IAEA INTERNATIONAL PEER REVIEW MISSION ON MID-AND-LONG-TERM ROADMAP TOWARDS THE DECOMMISSIONING OF TEPCO'S FUKUSHIMA DAIICHI NUCLEAR POWER STATION UNITS 1-4 (Third Mission)

**Tokyo and Fukushima Prefecture, Japan
9 – 17 February 2015**

**MISSION REPORT TO
THE GOVERNMENT OF JAPAN**

FIG. 2. Contaminated water treatment and storage scheme.

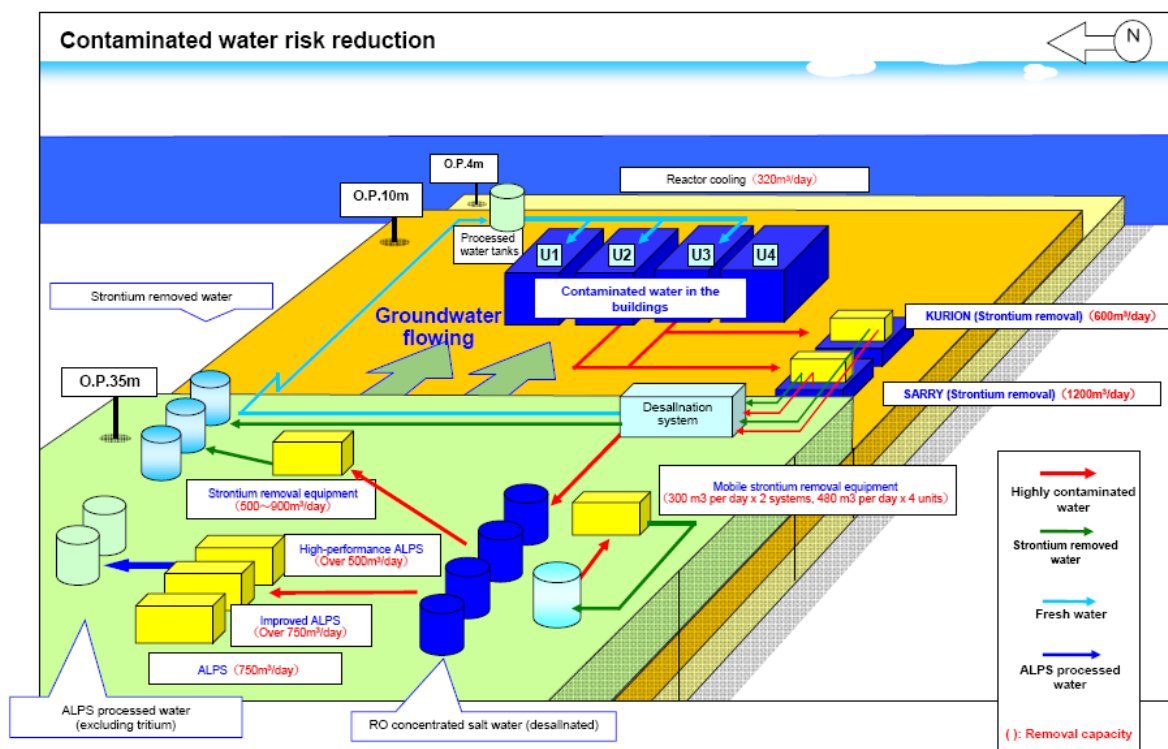
Whilst acknowledging TEPCO's efforts to reduce the risk of storing large volumes of highly radioactive water by removing strontium and other radionuclides as quickly as possible, the IAEA team believes waste minimization should also be an important consideration in such efforts.

Each new piece of equipment adds to the radioactive waste to be managed, and several more items are planned for installation. The IAEA team was informed that this was done because available treatment capacity was not sufficient to meet target deadlines. For example, the actual operating capacity of the three ALPS systems has been only 1200 m³/day as compared to their full design capacity of 2000 m³/day. Discussions during the mission indicate that this shortfall may be related to the complexity of the treatment flow sheets and the use of newly developed selective sorbents being industrially deployed for the first time. There is, for example, a need for frequent cleaning or replacement of the cross flow filters in the first two ALPS systems, resulting in significant downtime. Lower than expected service life of strontium sorbent in the high performance ALPS system is another example. Obviously, fine-tuning operating conditions and achieving performance targets for these systems is taking more time than initially estimated. TEPCO needs to resolve these issues promptly and optimize the various processes.
